**Licensee** Millennium Minerals Limited

**Licence Number** L8675/2012/1

**Date of amendment** 14 March 2017

## Amendment Notice

### Premises map

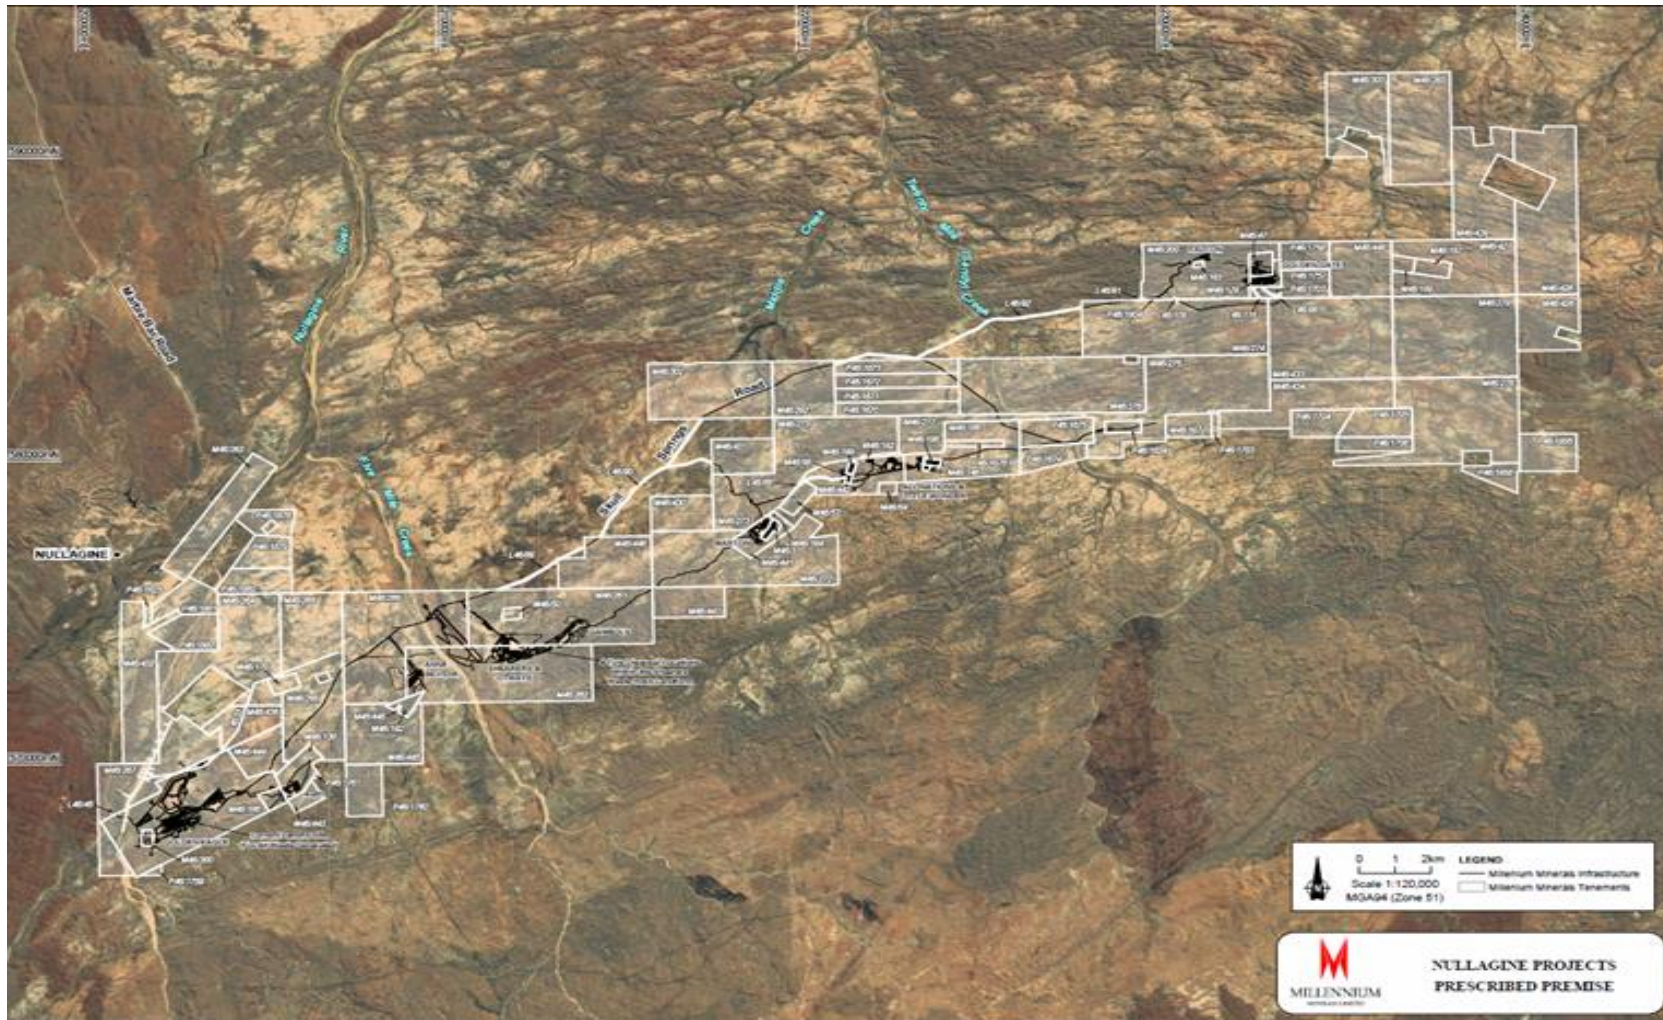
- Premises tenure has been updated as some tenure were invalid or no longer registered with DMP (MML, 2016c). The premises map has been amended via this Notice (Attachment 1).

21. The Premises map in Schedule 1 is deleted and replaced with the map in Attachment 1 of this Notice.
22. The Map of storage locations in Schedule 1 is deleted and replaced with the map in Attachment 2 of this Notice.

### Map of storage locations

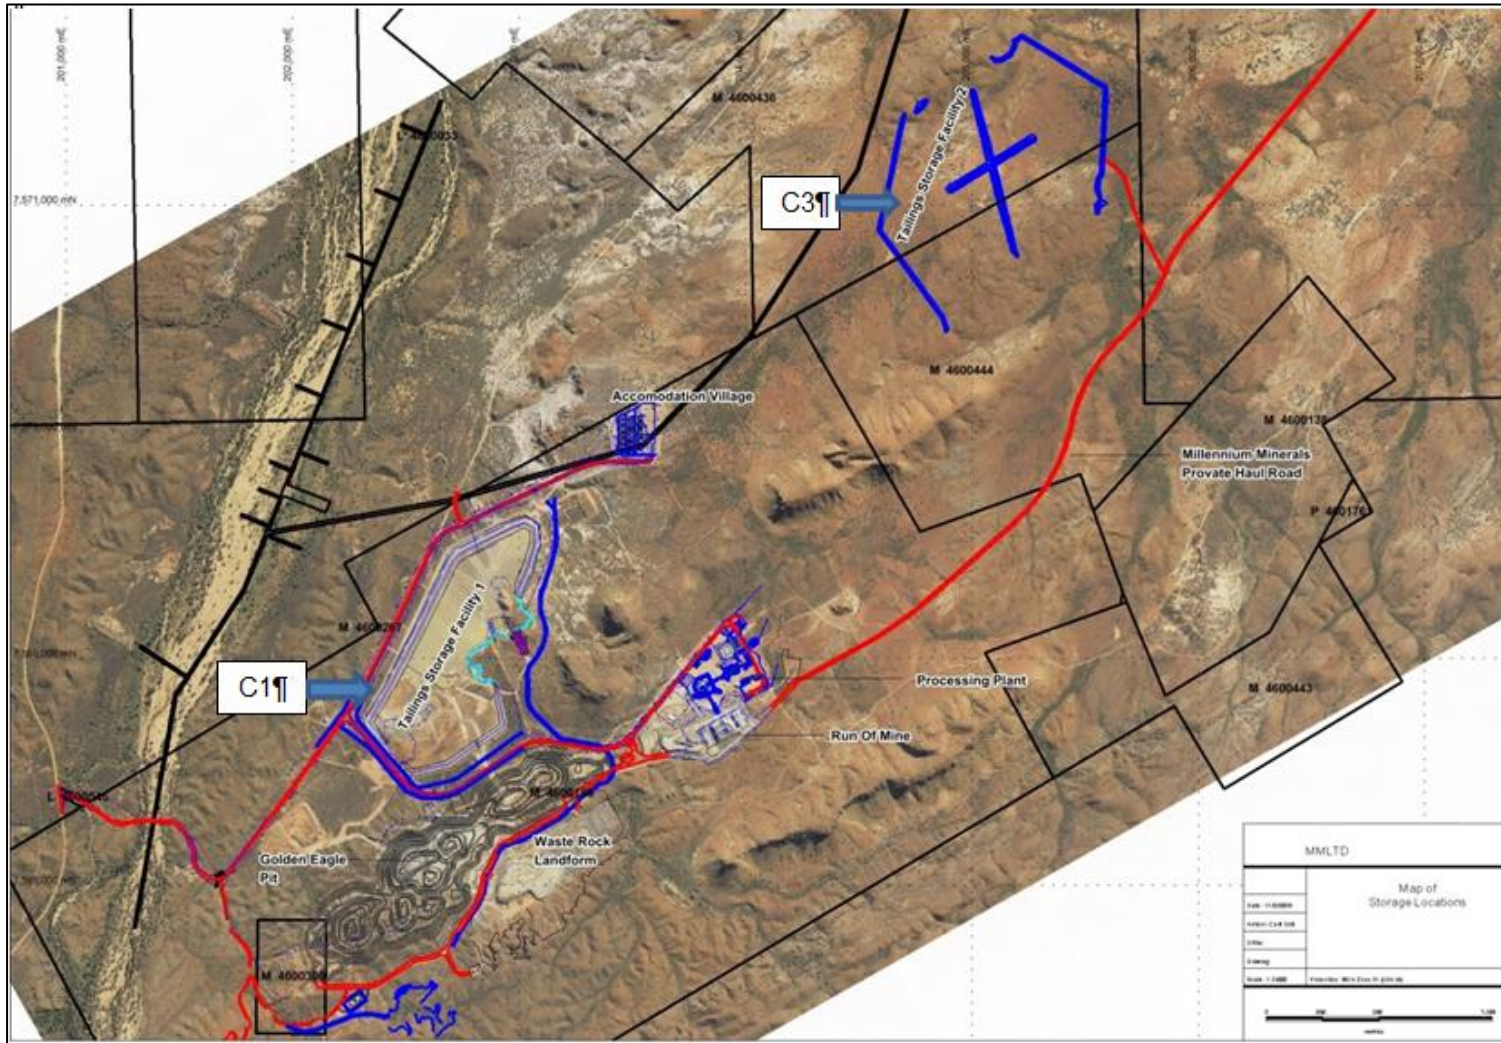
Existing Condition 1.3.3 has been updated via this Notice to include TSF2 (C3) and associated containment infrastructure requirements. The previous map of storage locations has been replaced via this Notice (Attachment 2) to include C3.

<b>Table 1.3.1: Containment infrastructure</b>			
<b>Containment point reference</b>	<b>Containment cell or dam number(s)</b>	<b>Material</b>	<b>Infrastructure requirements</b>
C1	<del>TSF1</del>	<del>Tailings and treated effluent from the wastewater-treatment plant</del>	<del>Stage 4 lift to RL 406.5m <u>at completion</u></del>
C2	Process Pond	Tailings thickener overflow, decant return, process catchment water and bore water from production bores 6B and 6C	Lined with high density polyethylene liner with a permeability of at least $<10^{-9}$ m/s or equivalent
<b><u>C3</u></b>	<b><u>TSF2</u></b>	<b><u>Tailings and treated effluent from the sewage treatment plant</u></b>	<b><u>Lift to RL 399.0m at completion</u></b>  <b><u>Permeability across the base of TSF meets <math>1 \times 10^{-9}</math> m/s or less</u></b>  <b><u>Underdrainage system installed at the base of TSF cell 1 and cell 2 draining to underdrainage collection sumps depicted in Figure 1 and 2</u></b>  <b><u>Toe drain depicted in Figure 1 and 2</u></b>

### Map of monitoring locations

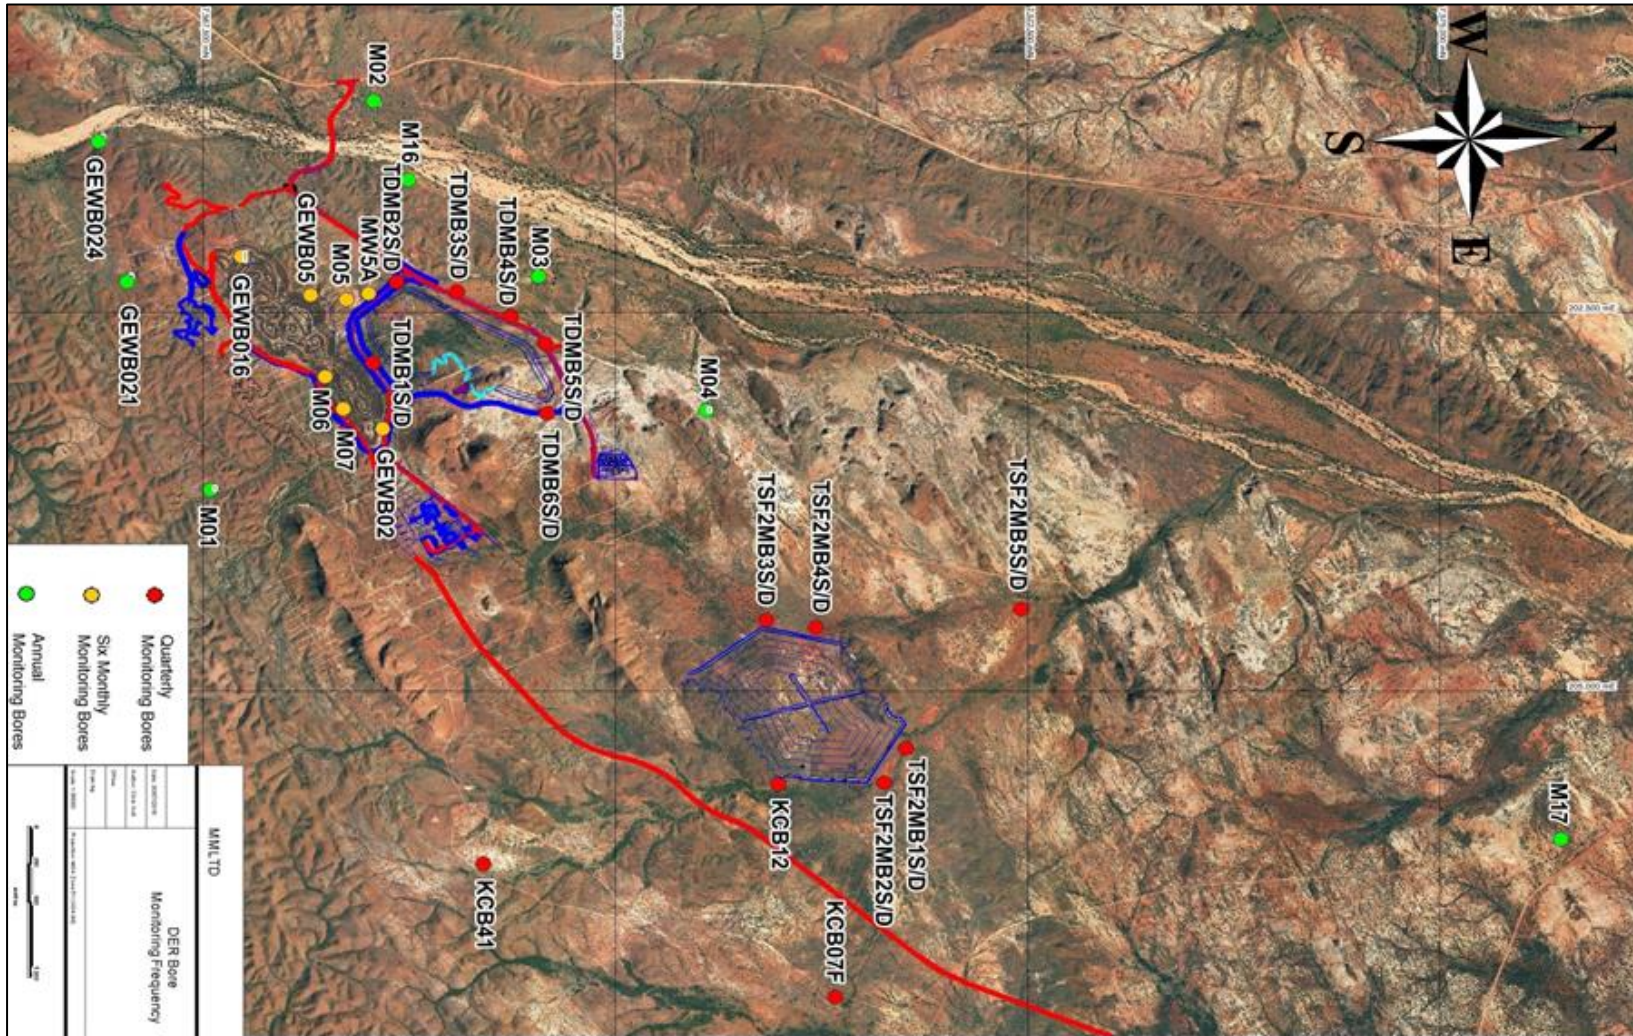
Condition 3.4.1 has been updated via this Notice to incorporate the groundwater monitoring bores (TSF2MB1S/D to TSF2MB5S/D, KCB07F, KCB12 and KCB41) associated with TSF2.

The previous map of monitoring locations has been replaced (Attachment 3) and the map of production bores has been included (Attachment 4) via this Notice.

23. The Map of monitoring locations in Schedule 1 is deleted and replaced with the map in Attachment 3 of this Notice.
24. The licence is amended by the insertion of the Map of production bores in Attachment 4 of this Notice.

<b>Monitoring point reference</b>	<b>Parameter</b>	<b>Limit</b>	<b>Units</b>	<b>Averaging period</b>	<b>Frequency</b>
<u>TDMB6S/D,</u> <u>TSF2MB1S/D,</u> <u>TSF2MB2S/D,</u> <u>TSF2MB3S/D,</u> <u>TSF2MB4S/D,</u> <u>TSF2MB5S/D,</u> <u>KCB07F, KCB12,</u> <u>KCB41</u>					
GEWB01, GEWB02, GEWB04, GEWB05, GEWB06, GEWB09, GEWB012A, GEWB013A, GEWB014A, GEWB015, GEWB016, GEWB019, GEWB020, GEWB023, GEWB07, GEWB08, GEWB012, GEWB013, GEWB014, GEWB021, GEWB024, M01- M07, M16, M17, TDMB1S/D, TDMB2S/D, TDMB3S/D, TDMB4S/D, TDMB5S/D, TDMB6S/D, <u>TSF2MB1S/D,</u> <u>TSF2MB2S/D,</u> <u>TSF2MB3S/D,</u> <u>TSF2MB4S/D,</u> <u>TSF2MB5S/D,</u> <u>KCB07F, KCB12,</u> <u>KCB41</u>	Water level	None specified	mbgl	Spot sample	Monthly

Figure 1: Diagram depicting the underdrainage system, decant structure, toe drain and piezometers

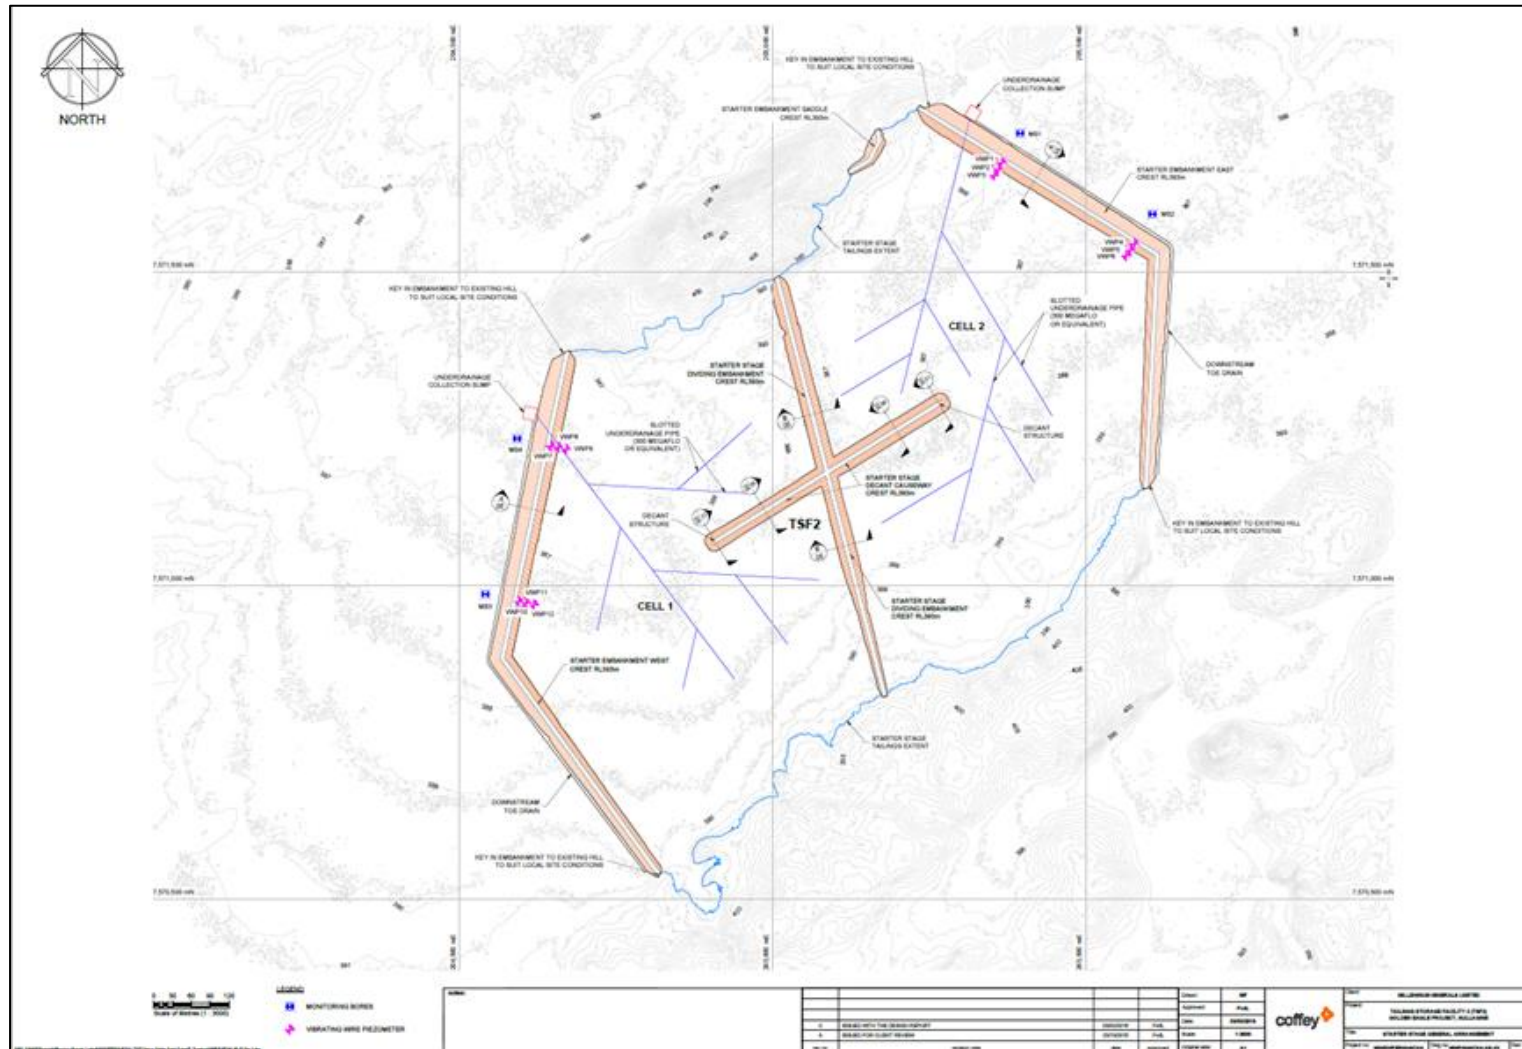
The Licence Holder has committed to constructing TSF2 to the specifications provided in MML, 2016a and Coffey, 2016. As cell one of TSF2 has already been constructed, Condition 1.3.16 has been added to the licence via this Notice for the infrastructure requirements for TSF2 and pipelines (tailings and return water). Figure 1 (diagram depicting the underdrainage system, decant structure, toe drain and piezometers) and Figure 2 (diagram depicting the alternative rock ring decant structure) have also been included (Attachments 5 and 6) via this Notice.

25. The licence is amended by the insertion of Figure 1 in Attachment 5 of this Notice
26. The licence is amended by the insertion of Figure 2 in Attachment 6 of this Notice.

<b>Table 1.3.7: Infrastructure requirements</b>	
<b>Infrastructure</b>	<b>Requirements (design)</b>
<u><b>TSF2</b></u>	<p><u><b>The TSF2 must:</b></u></p> <ul style="list-style-type: none"> <li><u>(a) <b>be no more than 109 hectares;</b></u></li> <li><u>(b) <b>be no more than RL 399.0m;</b></u></li> <li><u>(c) <b>include additional engineering works to the base to further reduce the hydraulic conductivity of regolith beneath the TSF footprint and to increase the uniformity of the hydraulic properties of these materials so that the permeability across the base meets <math>1 \times 10^{-9}</math> m/s or less;</b></u></li> <li><u>(d) <b>include an underdrainage system, comprising a finger drain network at the base of each cell to assist with the recovery of water from the consolidation of the tailings and to reduce potential seepage loss;</b></u></li> <li><u>(e) <b>include water return sumps installed at the lowest points and constructed using large diameter concrete pipes founded on a concrete base. The underdrainage system discharges any collected water into a water return sump as depicted in Figure 1 of Schedule 1;</b></u></li> <li><u>(f) <b>include piezometers TSF2MB1S/D, TSF2MB2S/D, TSF2MB3S/D, TSF2MB4S/D, TSF2MB5S/D monitored prior, during and after beaching operations across TSF2;</b></u></li> <li><u>(g) <b>include groundwater monitoring bores KCB07F, KCB12, KCB41 depicted in the map of monitoring locations in Schedule 1 with baseline monitoring conducted of the parameters listed in Table 3.4.1 locations during commissioning and before operation;</b></u></li> <li><u>(h) <b>include two production bores KCB12 and KCB12B to act as an interception and pump back system should they be required to manage any potential seepage as depicted in the map of production bores in Schedule 1;</b></u></li> <li><u>(i) <b>be designed to accommodate a 1 in 100 year 72 hour rainfall event;</b></u></li> <li><u>(j) <b>be designed to have a freeboard of 500mm above storm water capacity elevation; and</b></u></li> <li><u>(k) <b>include centrally located decant structures to recover the highest percentage of process water in each cell.</b></u></li> </ul>
